OSSF Inspection Sheet

Permit of Authorization to Construct an On-Site Sewage Facility Permit Valid For One Year From Date Issued

Permit Number: 118671
Issued This Date: 06/19/2025
This permit is hereby given to: Chris and Sheryl Vause

ON-SITE SEWAGE FACILITY APPLICATION

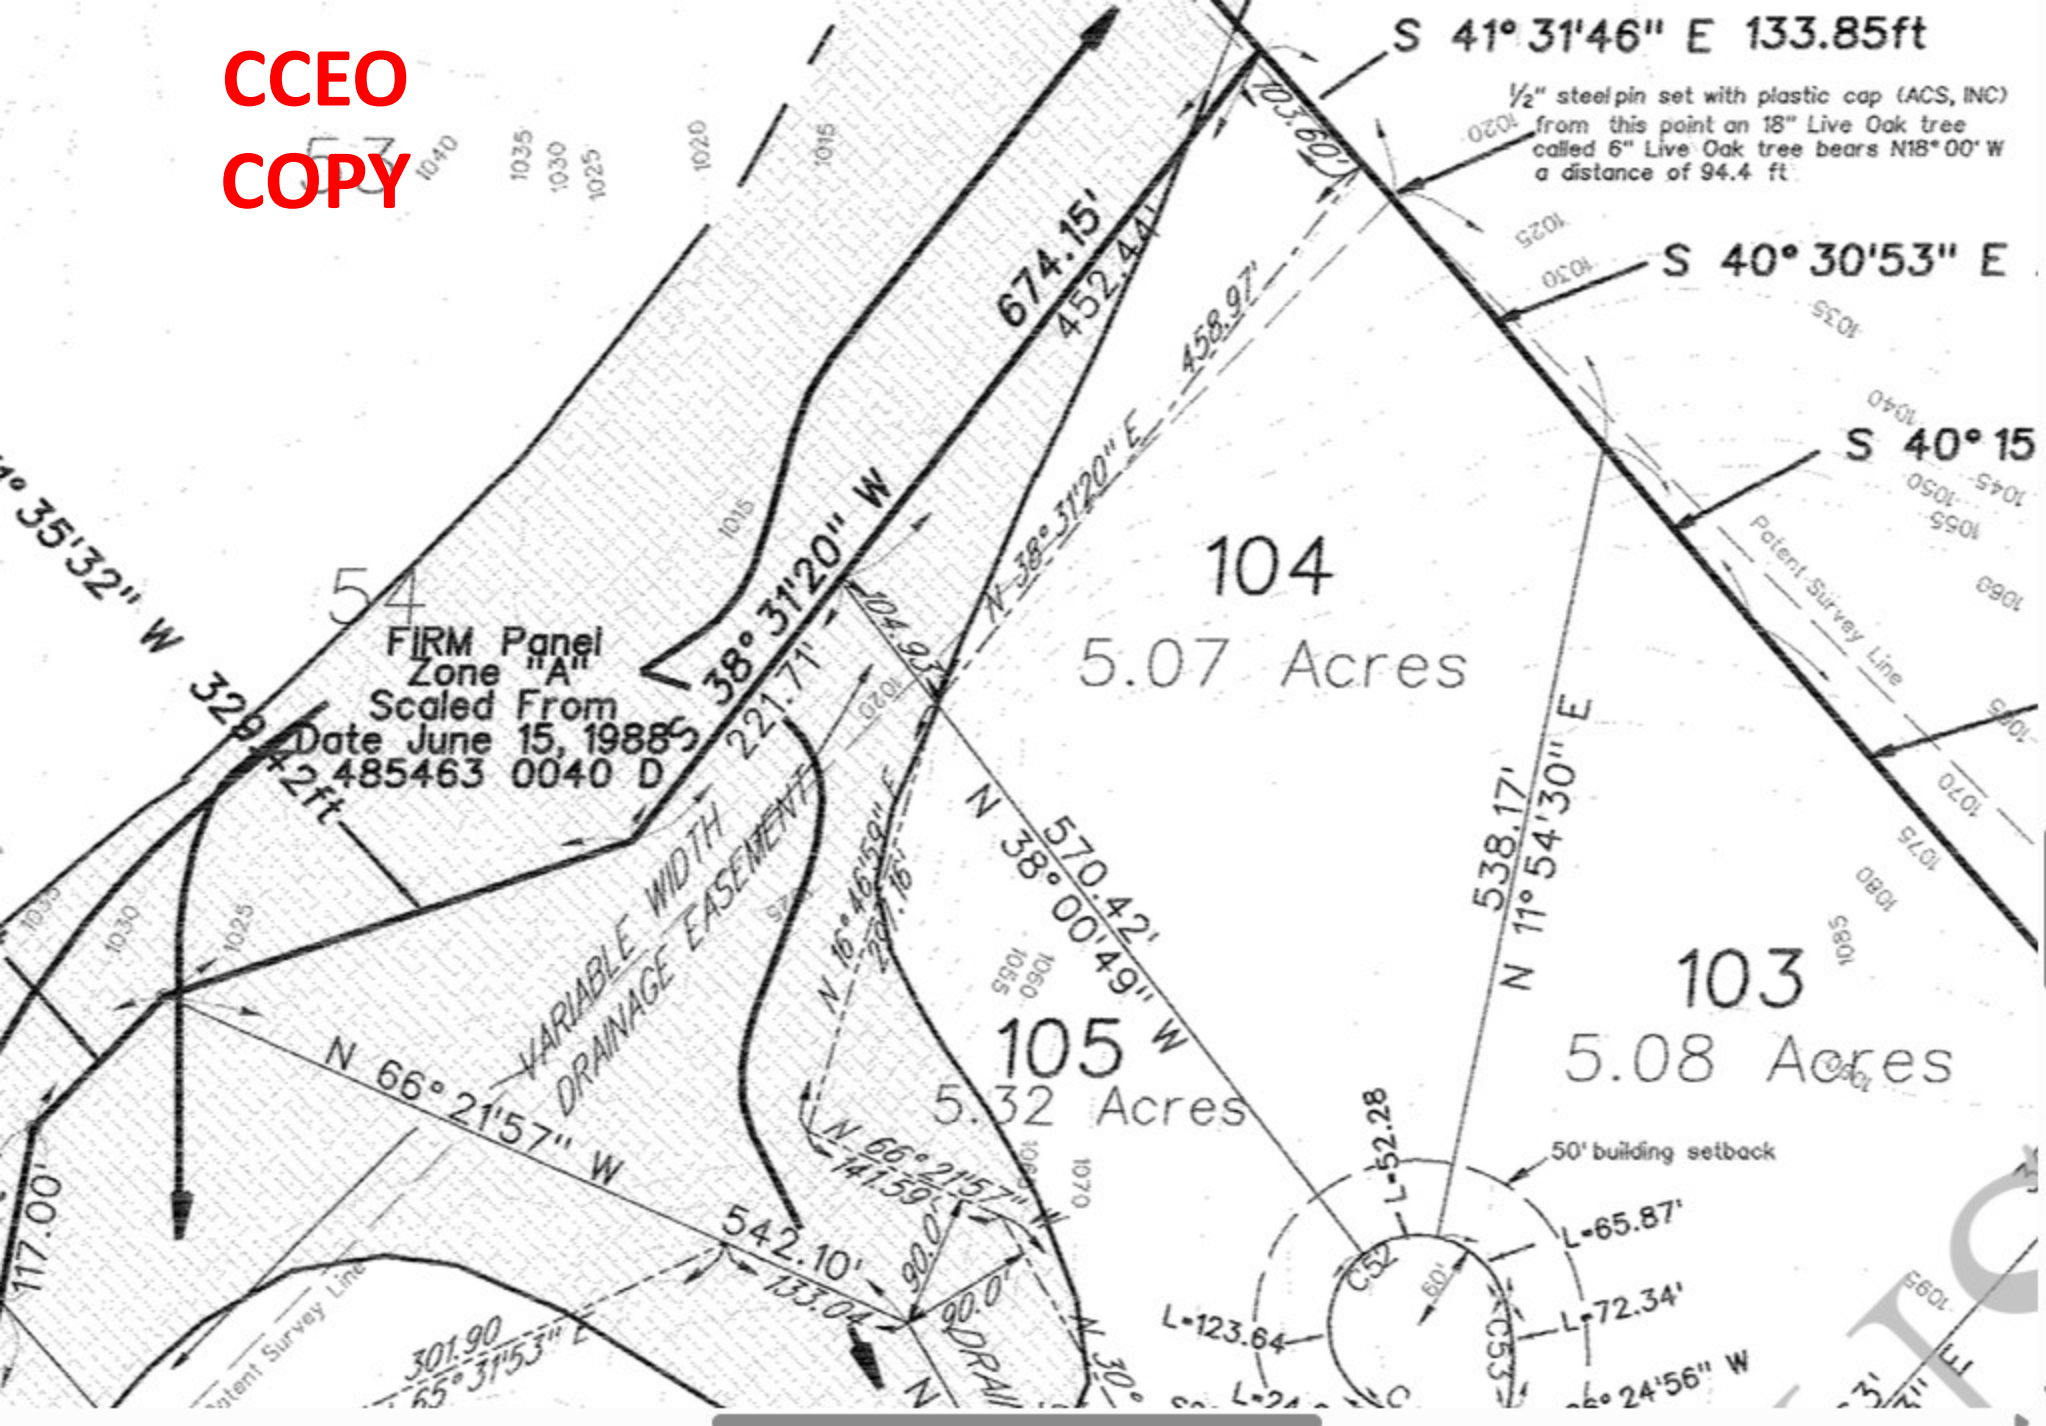
1.  The maintenance contract must indicate the physical address of the maintenance company.
2. Show the variable width drainage easement on the design.
3. Revise as needed and resubmit.
